Clinch River Project  
Project No. 99902056

Subject: **Response to Request for Additional Information eRAI-386 and Revised Quality Assurance Program Description for TVA New Nuclear Program, Topical Report NNP-TR-001-NP, Revision 1**

TVA Response to NRC Request for Additional Information dated January 27, 2023  
(eRAI-386)

FIGURE II.1-1 TVA NEW NUCLEAR ORGANIZATION

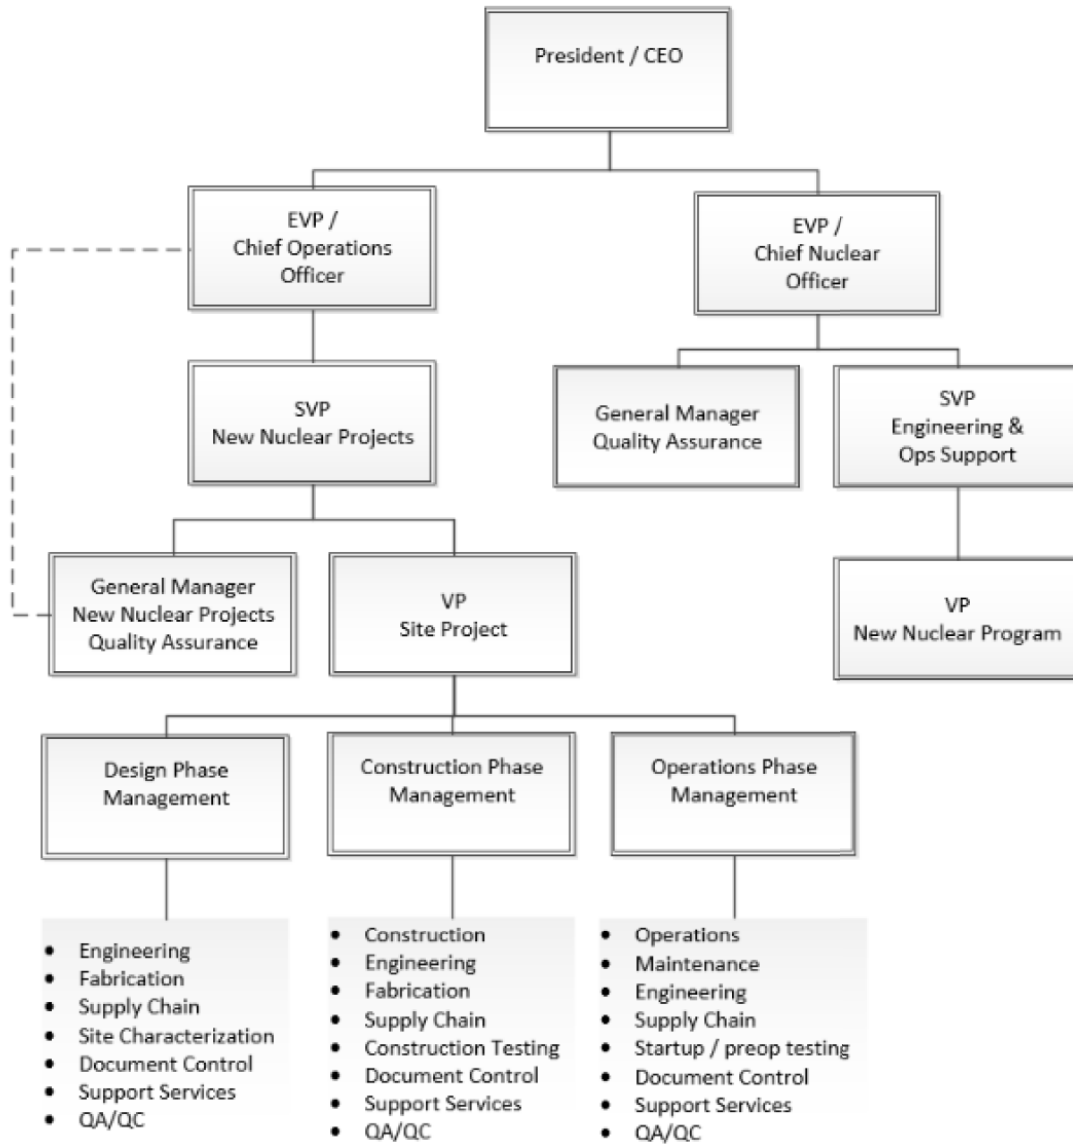
*Part II, Section I, “Organization” of the TVA New Nuclear Program QAPD TR describes the TVA New Nuclear Program organizational structure, functional responsibilities, levels of authority and interfaces for establishing, executing, and verifying QAPD implementation. This section states that the TVA New Nuclear organization is responsible for all aspects of design, construction, and operation of TVA’s New Nuclear plants. In addition, this section specifies that several organizations within the TVA New Nuclear Program implement and support the QAPD, which include engineering, operations support, and quality assurance. This section also states that the TVA New Nuclear Program oversees multiple sites and projects and Figure II.1-1 is provided to illustrate the TVA New Nuclear Program organization.*

*The NRC staff also reviewed the role of the Senior Vice President, New Nuclear Projects and the General Manager New Nuclear Quality Assurance, as described in Sections 1.5.1 and 1.5.2 of the TVA New Nuclear Program QAPD TR, Revision 0 and requests the applicant to clarify whether there is a specific QA person assigned to each new nuclear plant site during the operational phase who will be responsible for directing and managing the onsite QA program, to address the acceptance criteria in in Section 17.5, Subsection II, Item A.13.*

Figure II.1-1 has been revised to reflect the General Manager Quality Assurance for the TVA Nuclear Fleet, and the New Nuclear Programs and Projects reporting alignments as follows.
